Amendments to the Drawings:

DOCKET NO.: HITACHI-0012
Serial No.: 09/650,506
Amdt. dated April 27, 2004
Response to Office Action of October 27, 2003
Replacement Page

FIG. 1

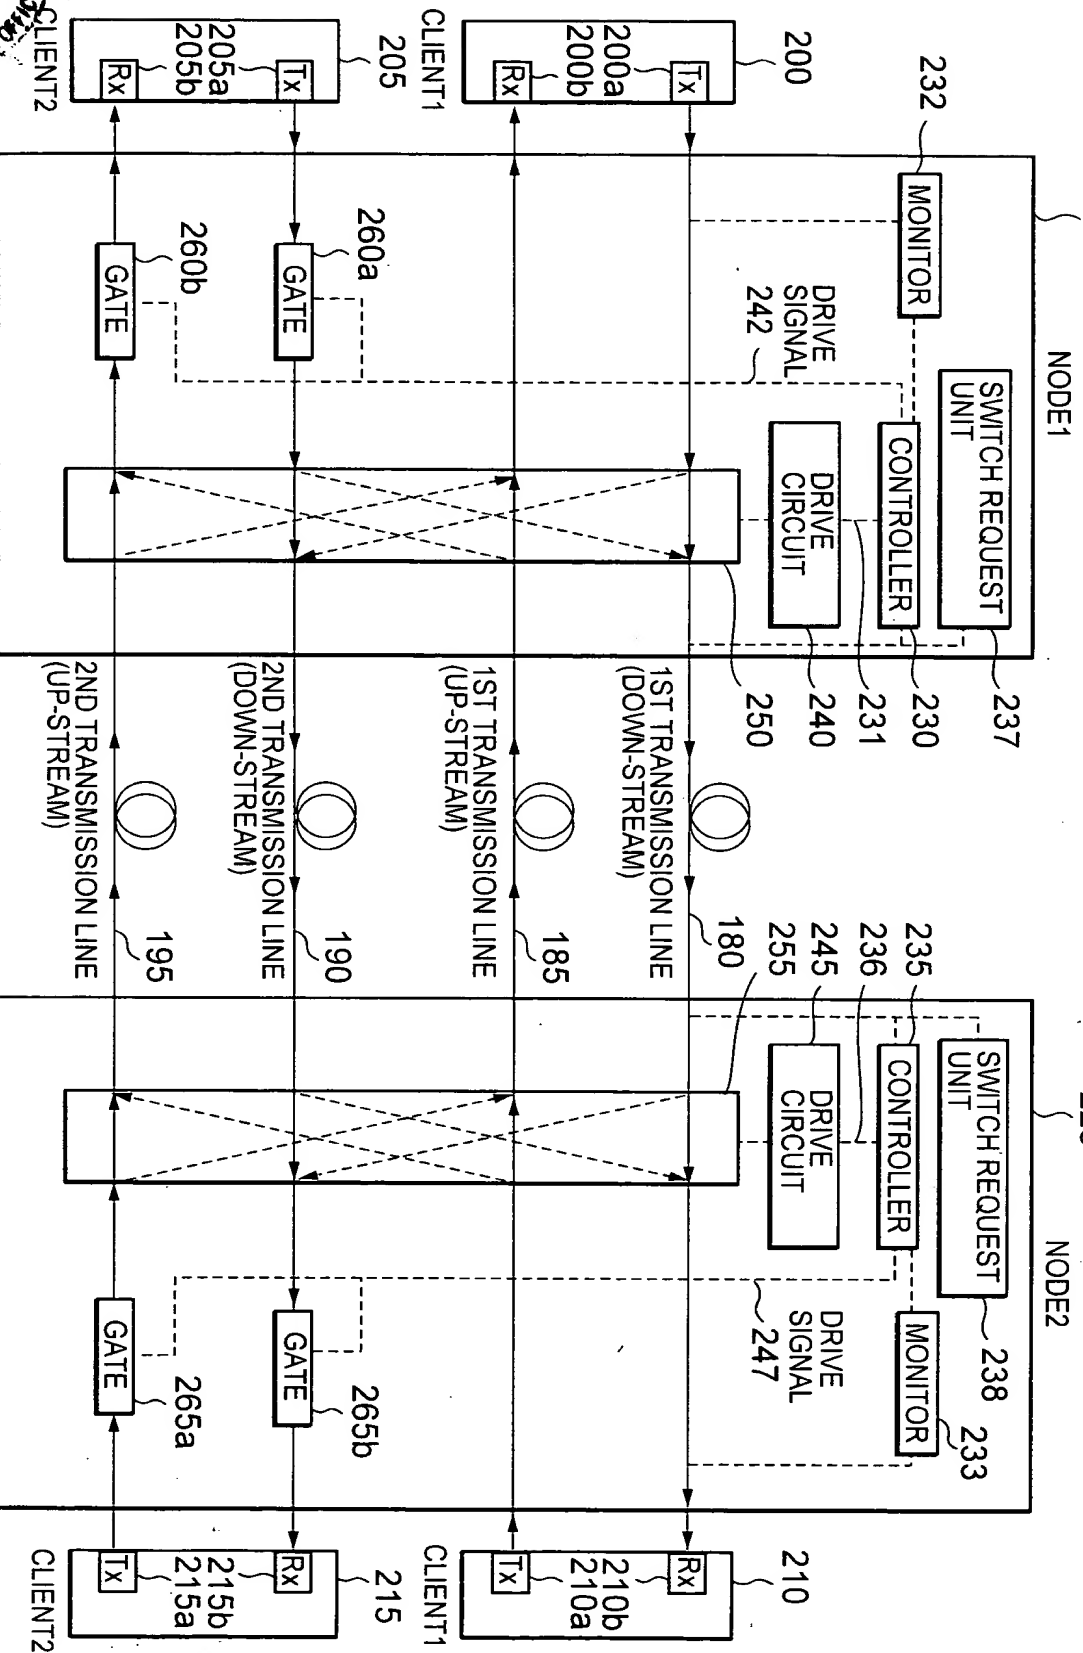
In Fig. 1, in the node 220, please add element 232 --MONITOR-- in the top left hand corner and element 237 --SWITCH REQUEST UNIT-- in the top right hand corner. Also in Fig. 1, in the node 220, please add dotted lines linking element 232 to element 230 and linking element 232 to "1ST TRANSMISSION LINE 180." Please also add dotted lines linking element 237 to "1ST TRANSMISSION LINE 180" and linking element 230 to "1ST TRANSMISSION LINE 180."

Also in Fig. 1, in the node 225, please add element 233 --MONITOR--in the top right hand corner and element 238 --SWITCH REQUEST UNIT-- in the top left hand corner. Also in Fig. 1, in the node 225, please add dotted lines linking element 233 to element 235 and linking element 233 to "1ST TRANSMISSION LINE 180." Please also add dotted lines linking element 238 to "1ST TRANSMISSION LINE 180" and linking element 235 to "1ST TRANSMISSION LINE 180."

FIG. 13 PRIOR ART

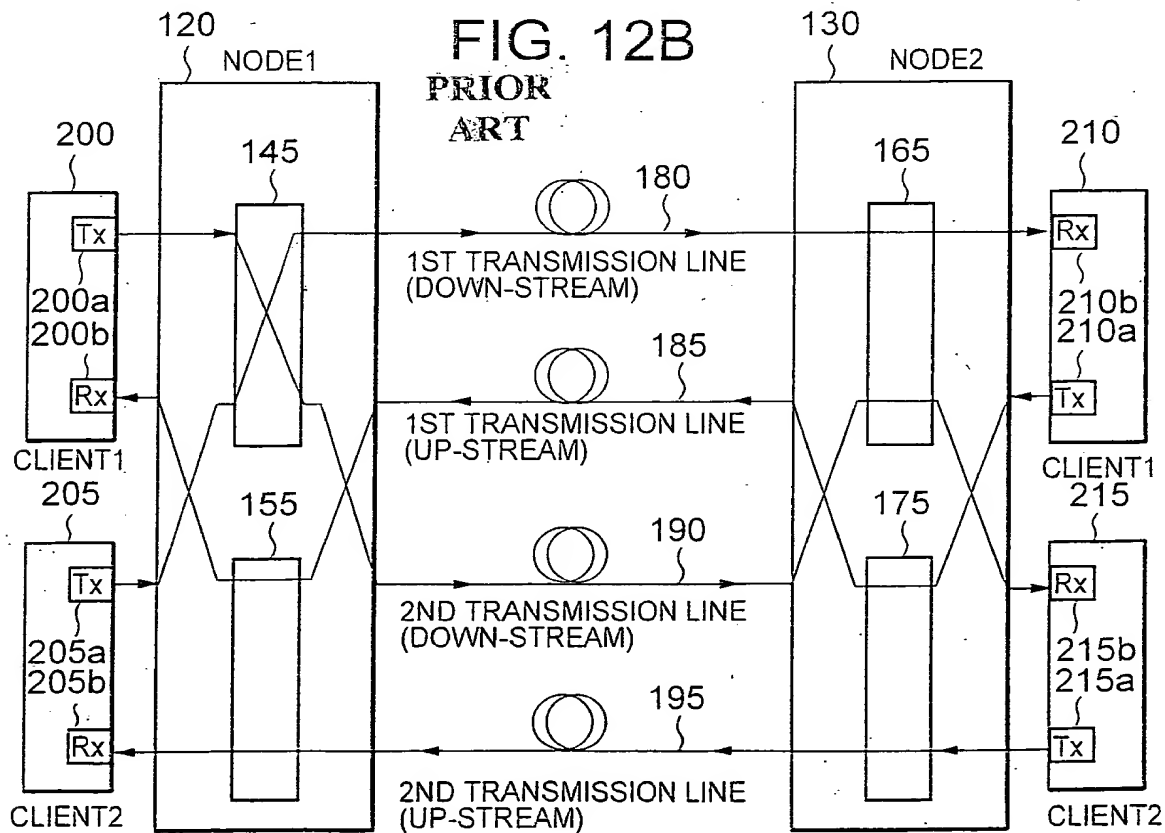
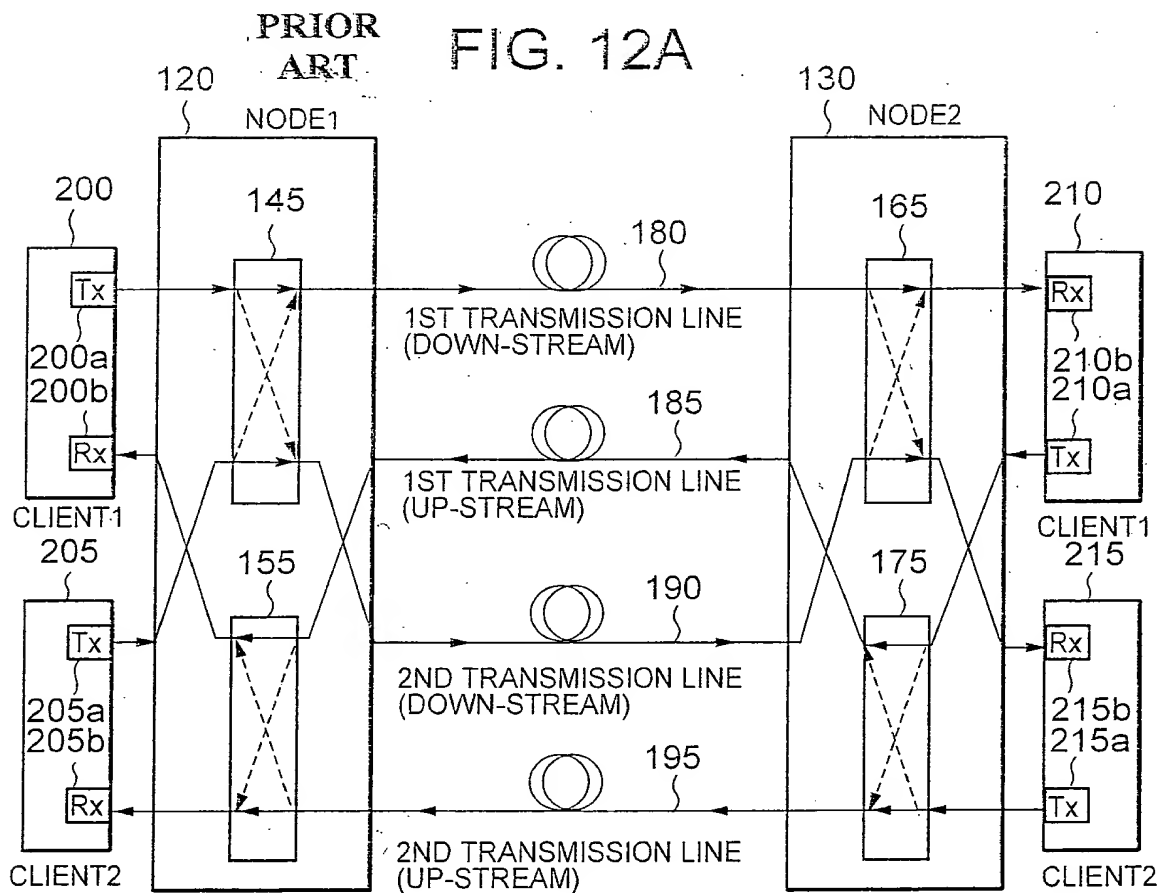
In Figs. 12A, 12B and 13, a "Prior Art" label has been added.
